Bryant Planning Commission Meeting

Date: October 13, 2025 - **Time:** 6:00 PM

DRC Report

CONTENTS: FINAL PLAT

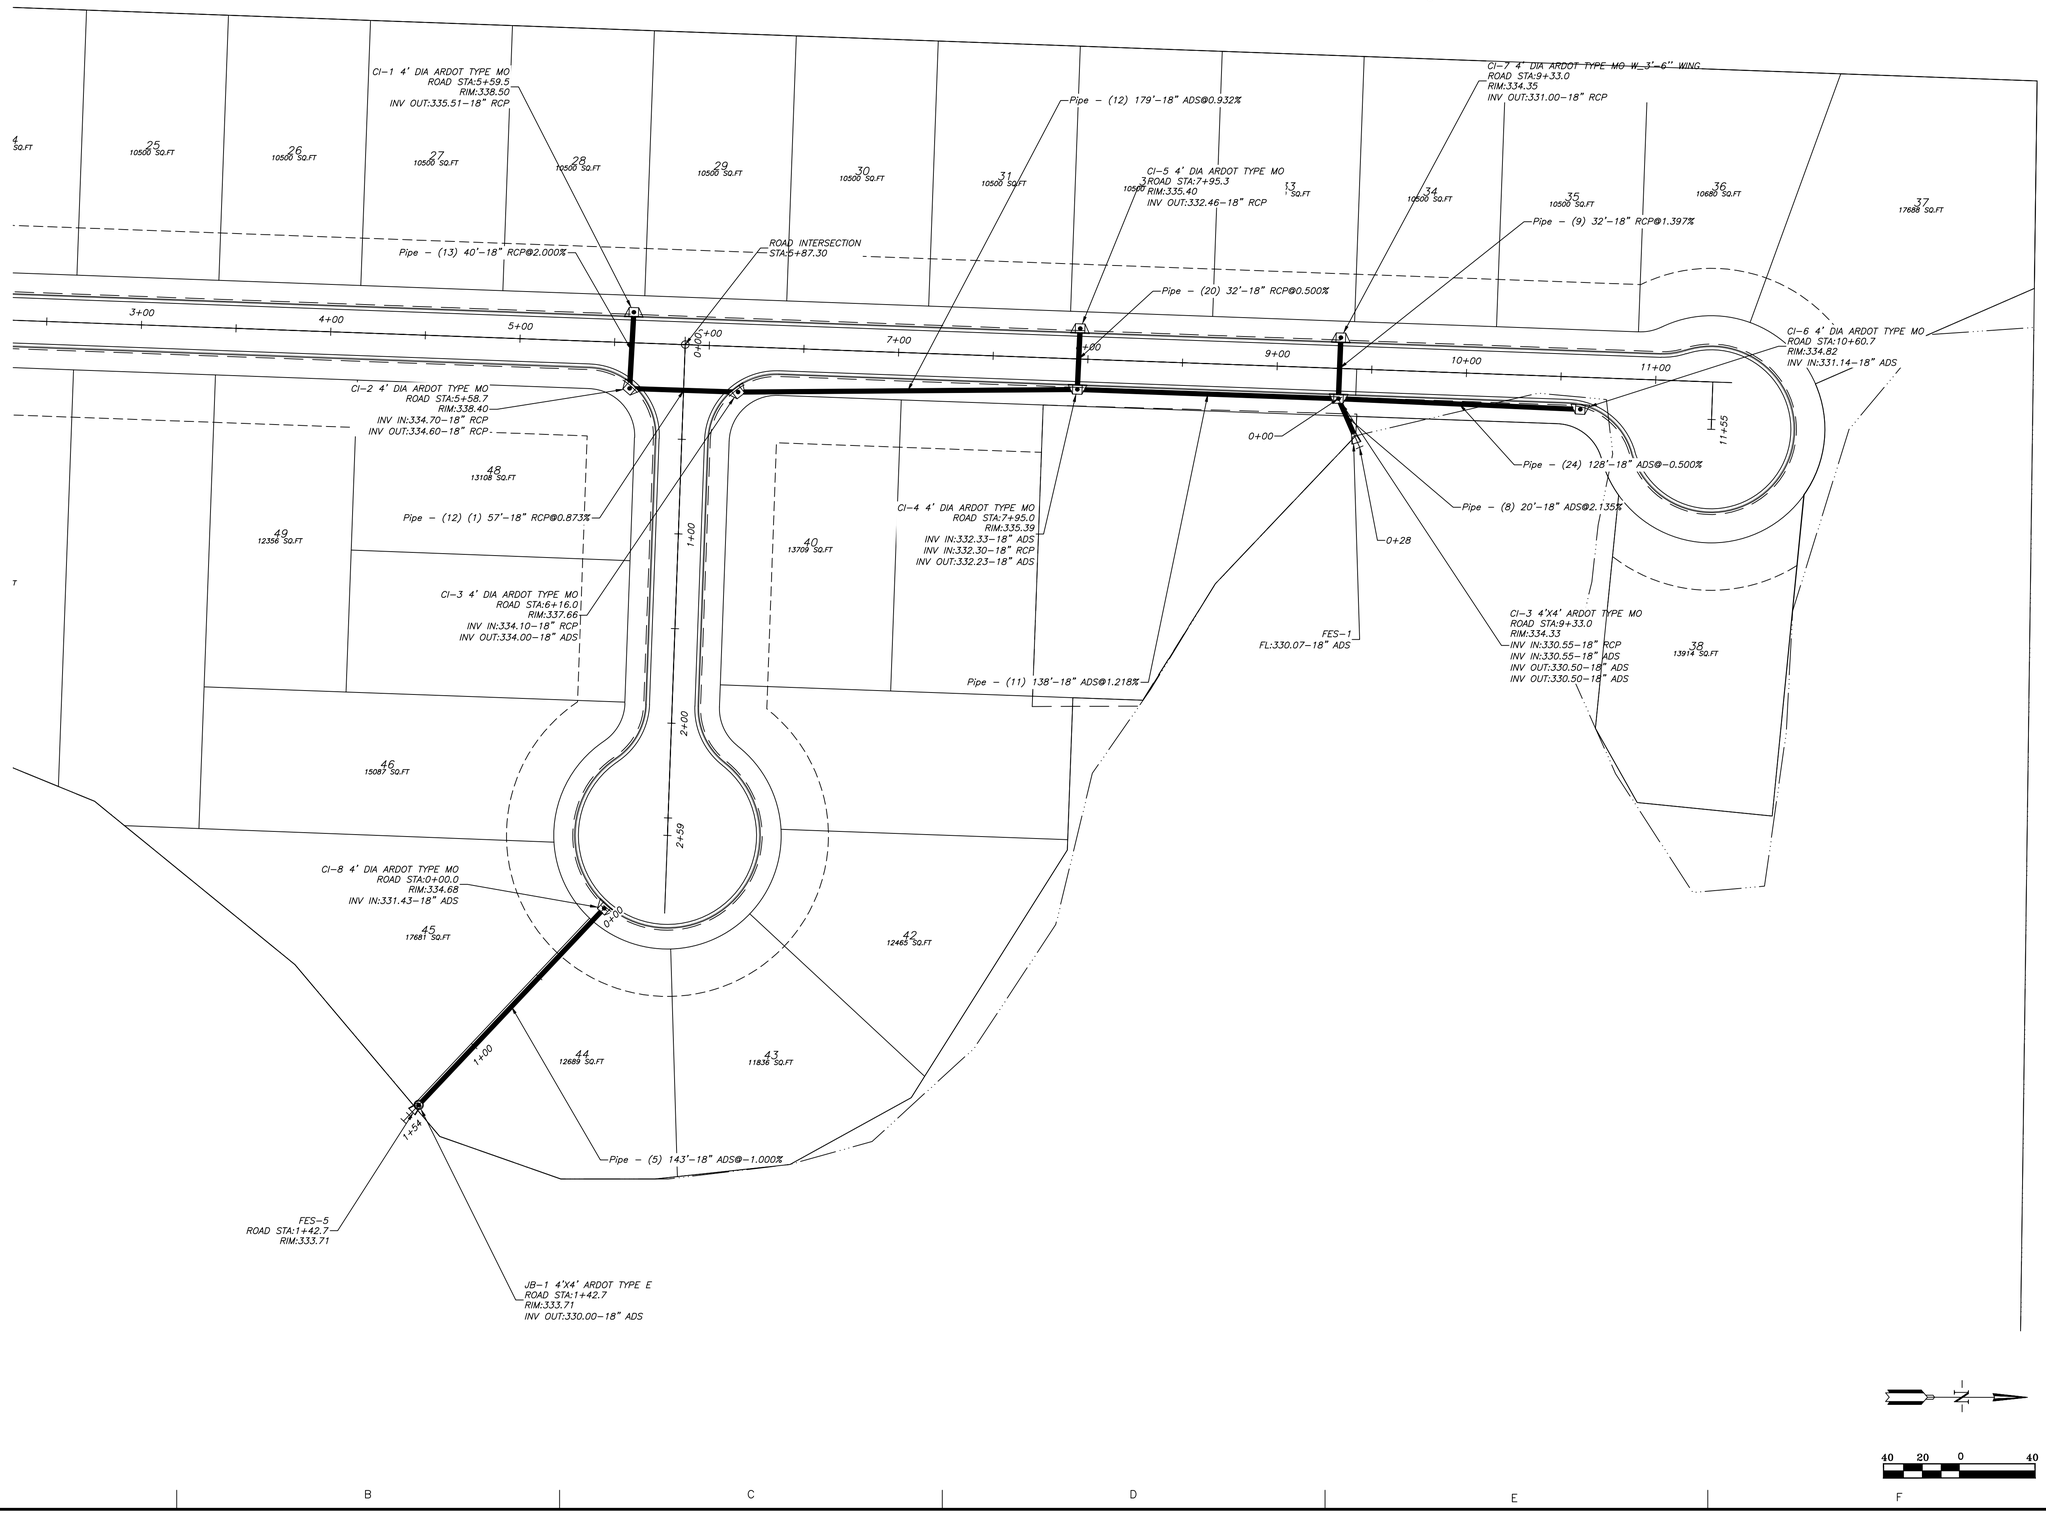
c. Engineering
    1. Label easements which are non-standard Will comply
    ii. Show existing road to tank site Will comply
    iii. Show existing property lines Will comply
    iv. Are there any other private roads planned? All private roads are shown on plat
    v. Are there any storm drainage system improvements planned (i.e. storm drains, inlets, etc.)? We are submitting plat only at this time.
    vi. Submit storm drainage calculations See response v.
    vii.
